Public Comment on TAC Agenda Item III.A 94 Langdon Street/98 Cornwall Street

From: David Rheume, P. E.
81 Langdon Street
To: Technical Advisory Committee

Meeting: April 7, 2026
Technical Advisory Committee
RE: 64 Bridge St (pages 307 to 338)
April 2, 2026

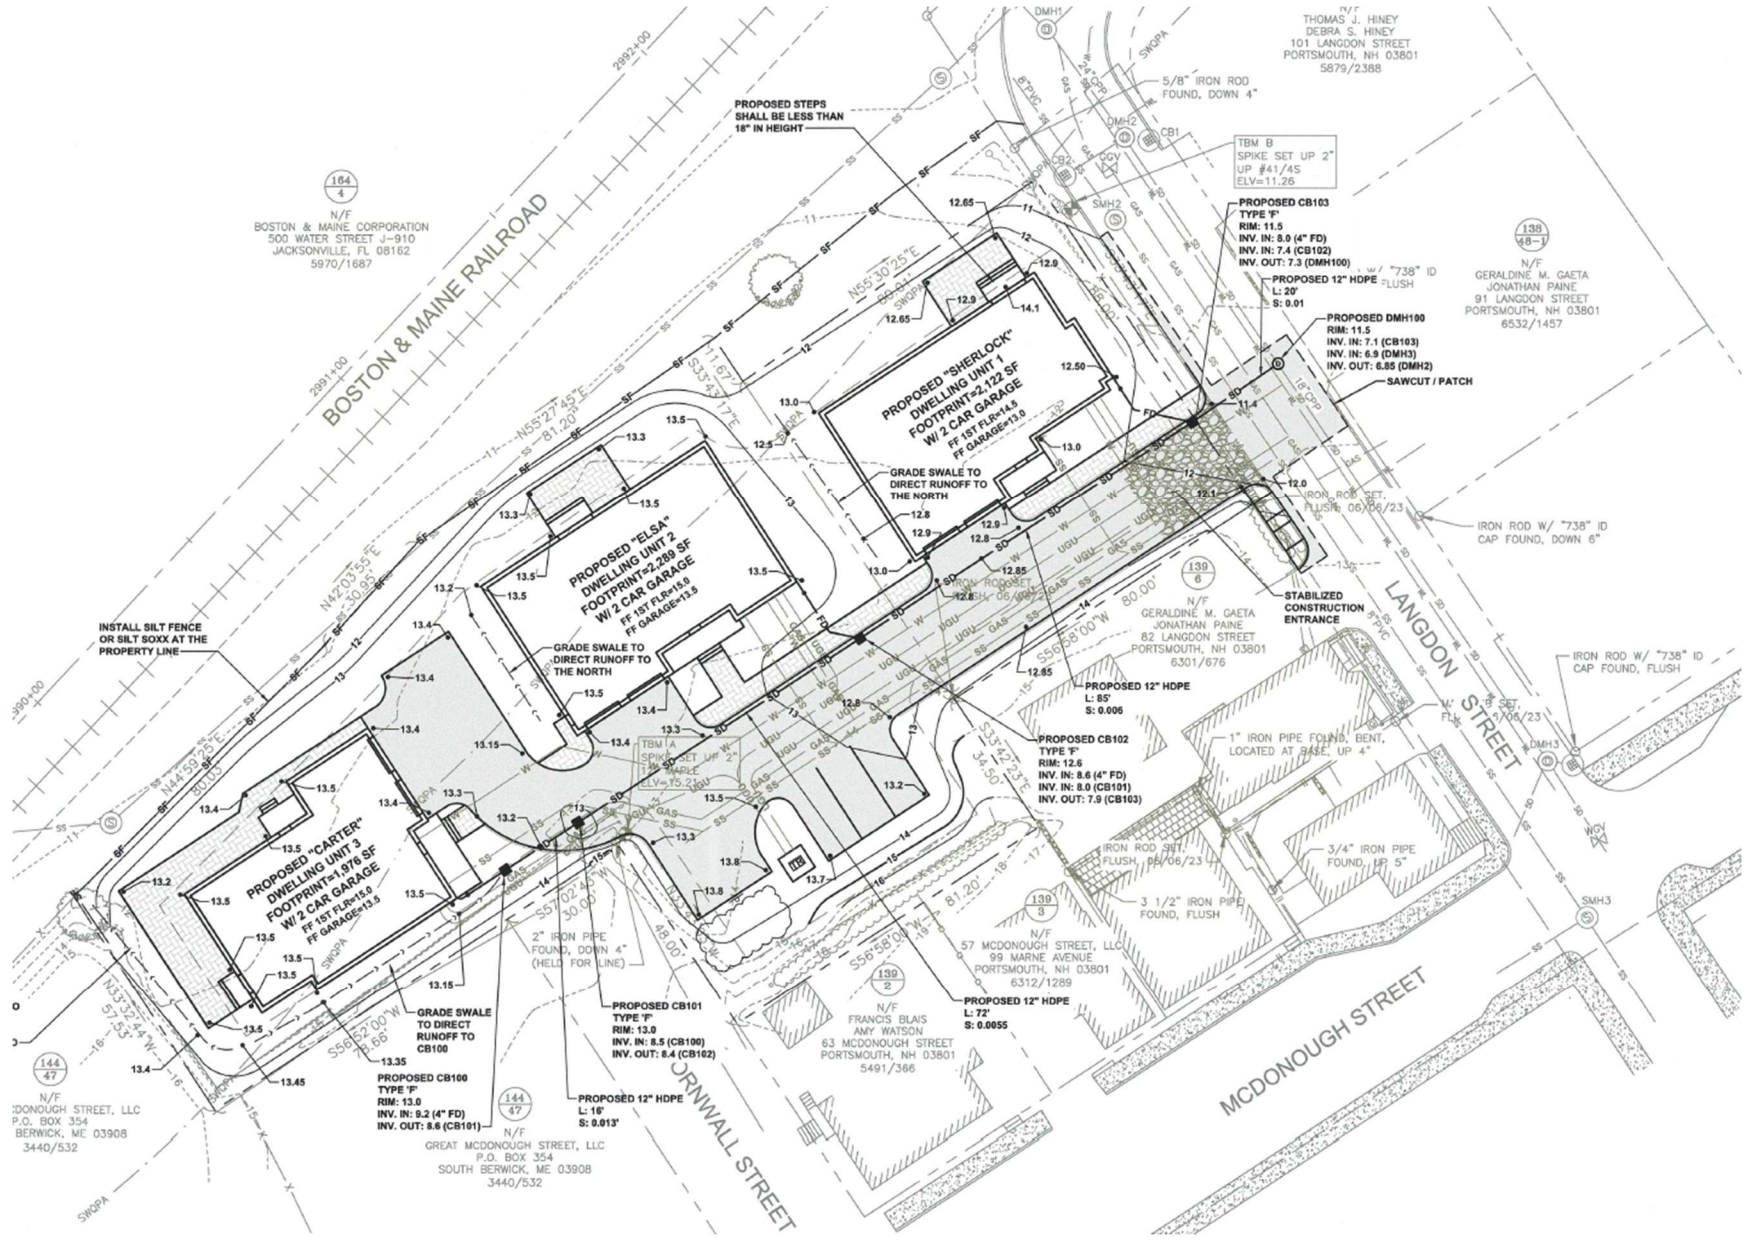
An excerpt from the developer's application to TAC is shown on page 4. It depicts the planned layout for the three single-family dwelling units, as well as the proposed common driveway that exits onto Langdon Street. It also illustrates that proposed Dwelling Unit 1 is oriented at a right angle to Langdon Street. The common driveway near Dwelling Unit 2 and Dwelling Unit 3 features a curve and vehicle turnout that almost connect to Cornwall Street.

The apparent vehicle turnaround shown on the applicant’s site plan could be reconfigured to be an ingress from Cornwall Street along the 48 feet of frontage that Lot 139-1 has along the east side of the street. This would leave room at the end of Cornwall Street for snow accumulation due to street plowing in the winter.

Elimination of the common driveway leading to Langdon Street could allow for a home to be positioned parallel to the street with a driveway having two parking locations in front of a two-car garage, mirroring the current configuration of the homes at 81, 82, 91 and 101 Langdon Street. It should still be possible to include a walking path from Dwelling Unit 2 and Dwelling Unit 3 across Condominium-owned land adjacent to Dwelling Unit 1 to allow pedestrian access for those two units to Langdon Street, facilitating easy walking access to Rock Street Park.

1920 Sanborn Map with Property Boundaries

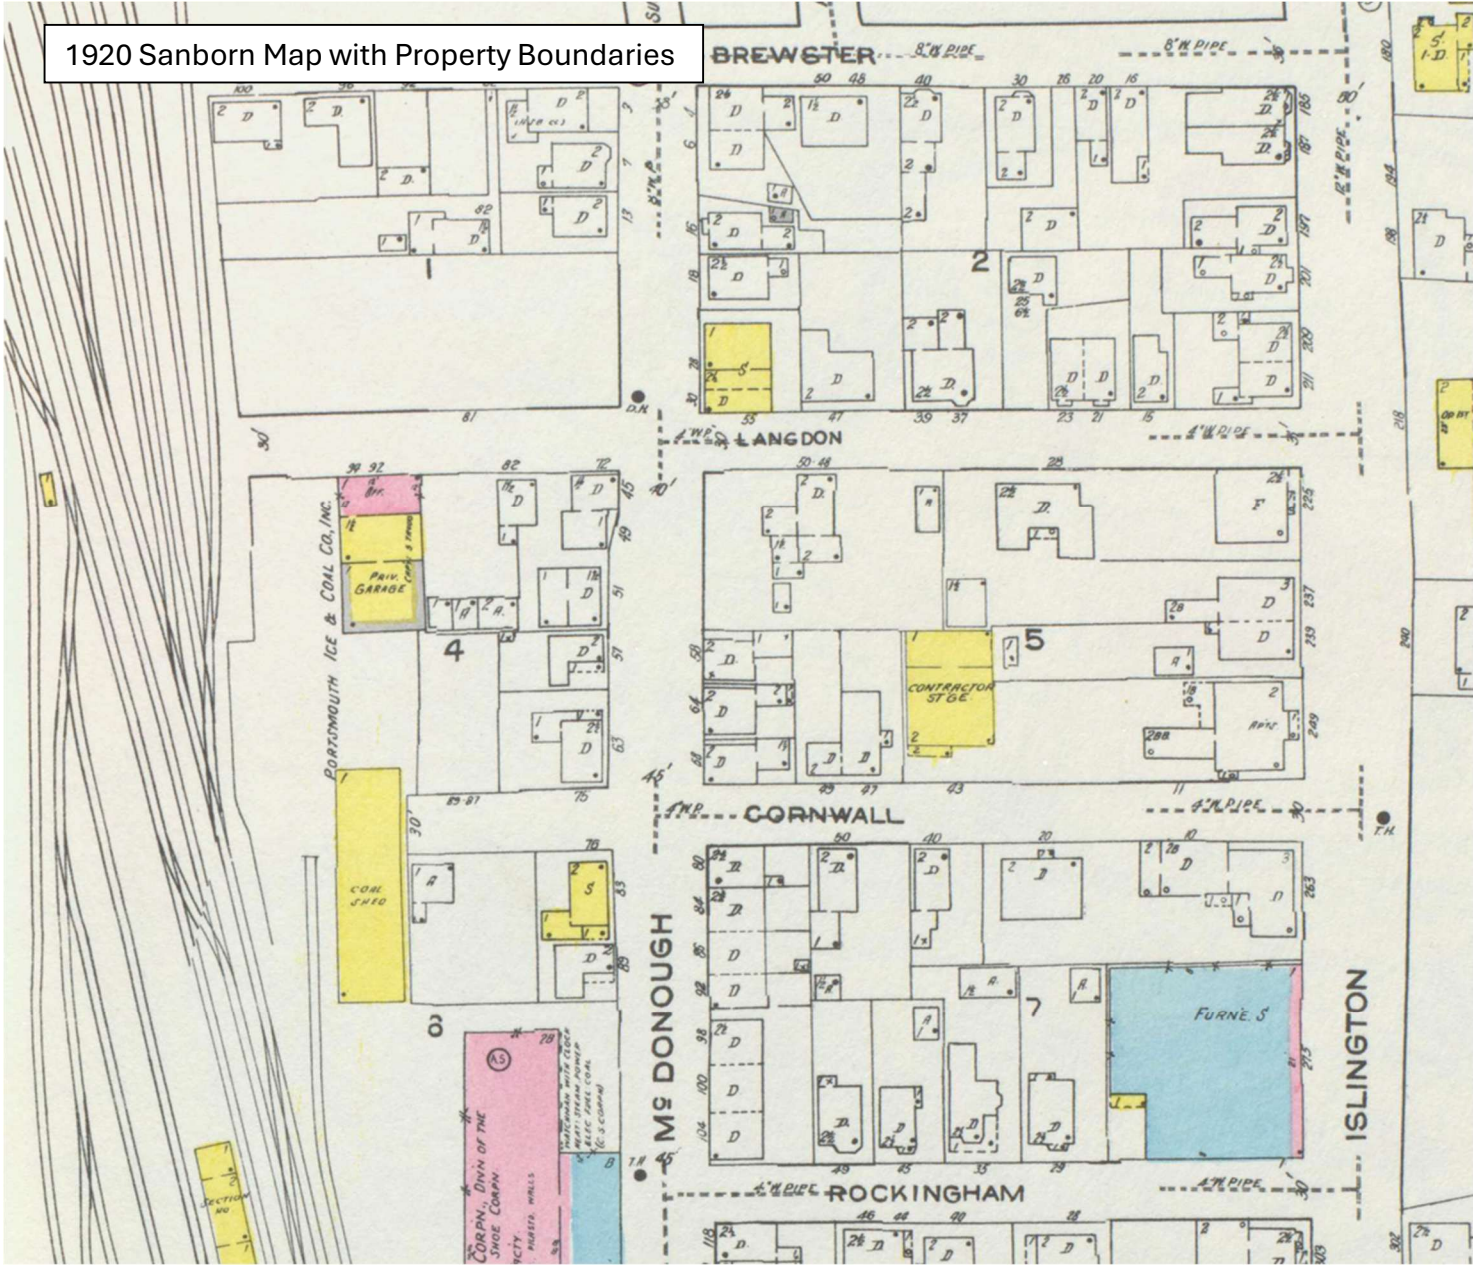
I have performed research of several historical maps that would seem to strongly indicate that Cornwall Street has long been viewed as extending to at least to the boundary of Lot 139-1 (“98 Cornwall Street”), and likely farther. Maps from 1850, 1871, 1876, 1892 and 1920 are provided on pages 5 through 9. The 1876 map is particularly illustrative as it depicts property boundaries which include two lots with homes (“J. H. Thompson” and “Wiggin”) that could only be accessed if Cornwall Street existed north of McDonough Street. The 1920 Sanborn Map also depicts property boundaries and shows one lot with a structure and one without that similarly require access to Cornwall Street. This map also shows how older lots had likely been merged and reconfigured to support the Portsmouth Ice and Coal Co., Inc., forming the present lots that are under development.

Map of the 2021 Neighborhood Pilot Parking Program

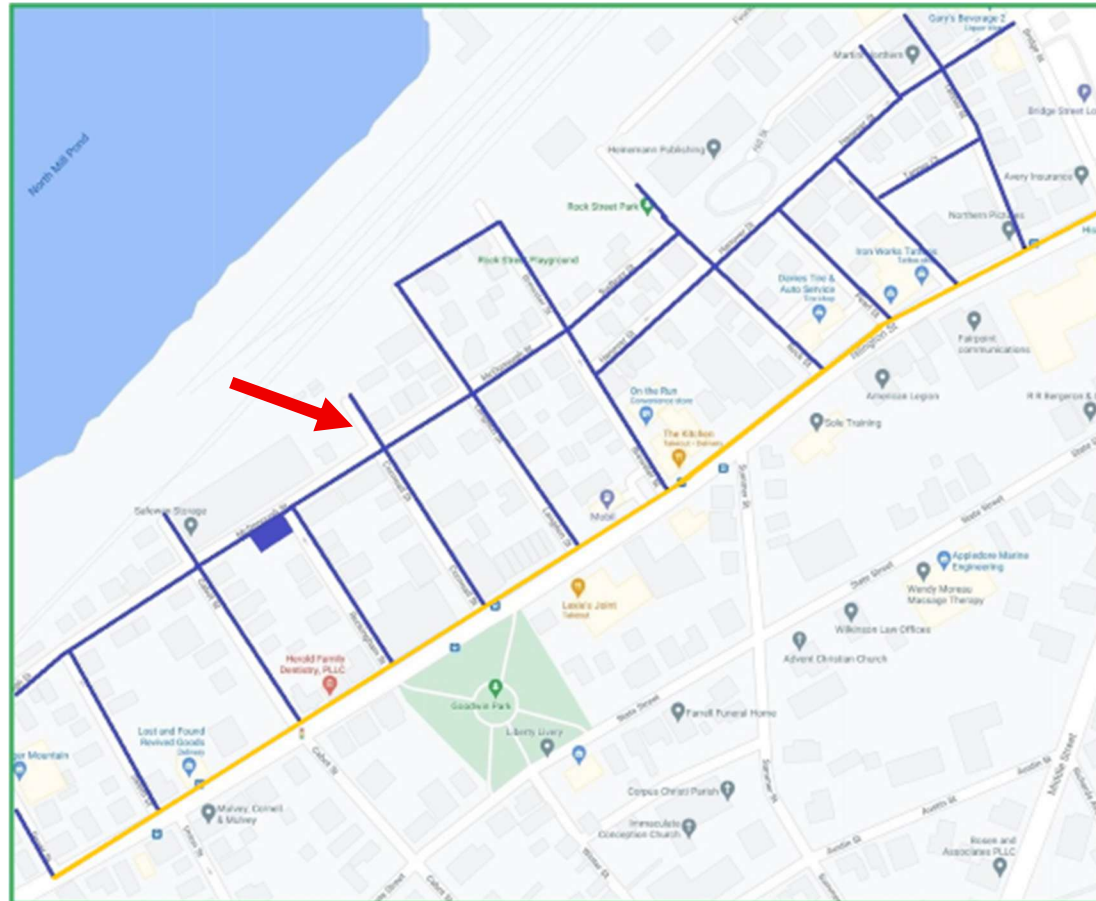
Additionally, circa 2020, a Neighborhood Pilot Parking Program was proposed and ultimately implemented. In both the 2019 and 2021 proposals for action by the City Council, the maps used to depict the affected streets included Cornwall Street north of McDonough Street, as shown by the map on page 10.

(Red arrow identifies that portion of Cornwall Street north of McDonough Street was identified by City Staff as being part of the program.)
